Airworthiness Directives; Sikorsky Aircraft Corporation Helicopters

2012-08-01 Sikorsky Aircraft Corporation:

Amendment 39-17017; Docket No. FAA-2011-1115; Directorate Identifier 2010-SW-011-AD.

Figure 1. Cat 'A' Takeoff and Landing Gross Weight

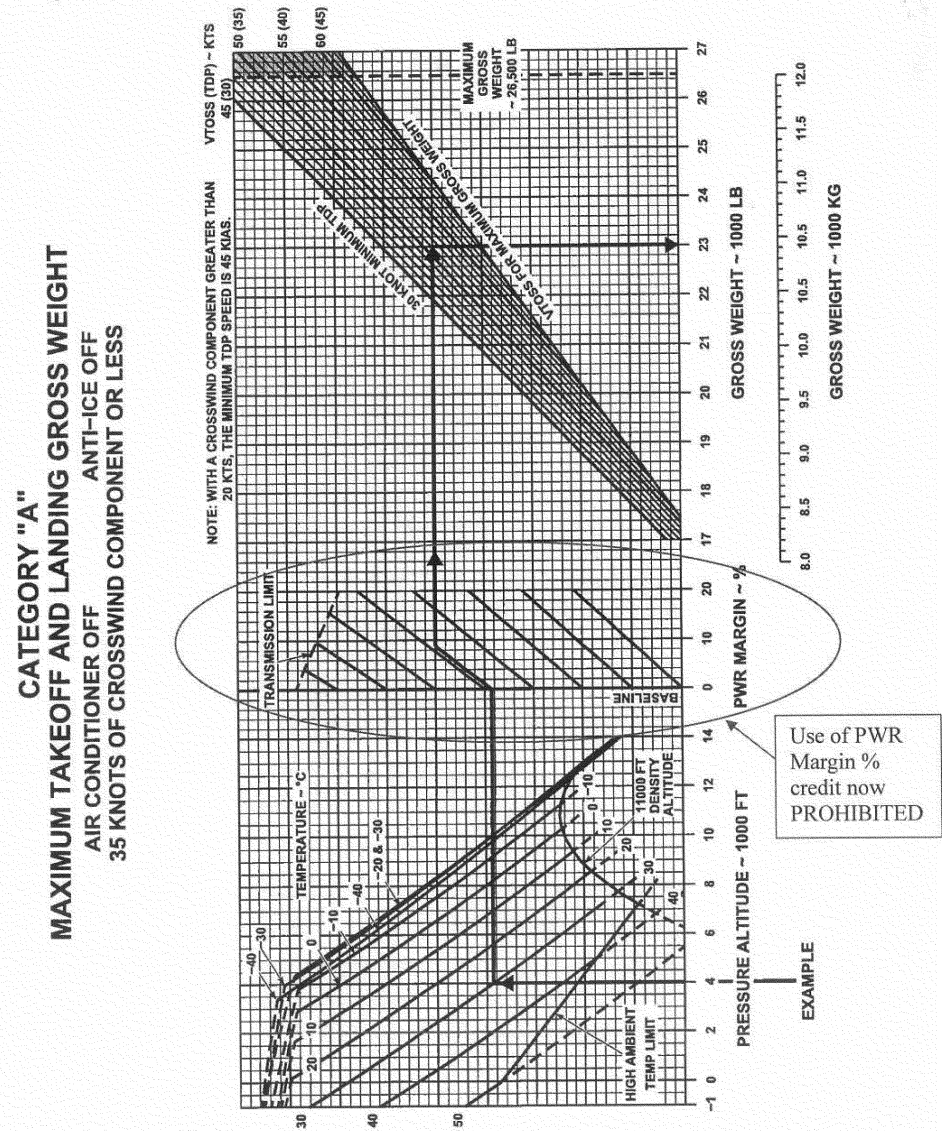
(2) If the RFM already contains the revisions appropriate for your helicopter as listed in the following Table 1, all dated April 9, 2008, with the correct performance charts, without the performance credit as depicted in the circled area of Figure 1 of this AD, the operating limitation required by paragraph (1) of this AD does not need to be inserted into the RFM.

Note to paragraph (e)(2) of this AD:
Previous RFM revisions allowed for the use of above-specification engine power margin as depicted in the circled area of Figure 1 of this AD.

(1) By making pen and ink changes, insert into the Operating Limitations section, Part 1, Section 1, Weight Limits, of Rotorcraft Flight Manuals (RFMs) SA S92A-RFM-002, -003, -004, -005, and -006 the following limitation “Performance credit for above specification engine power margin is prohibited.”
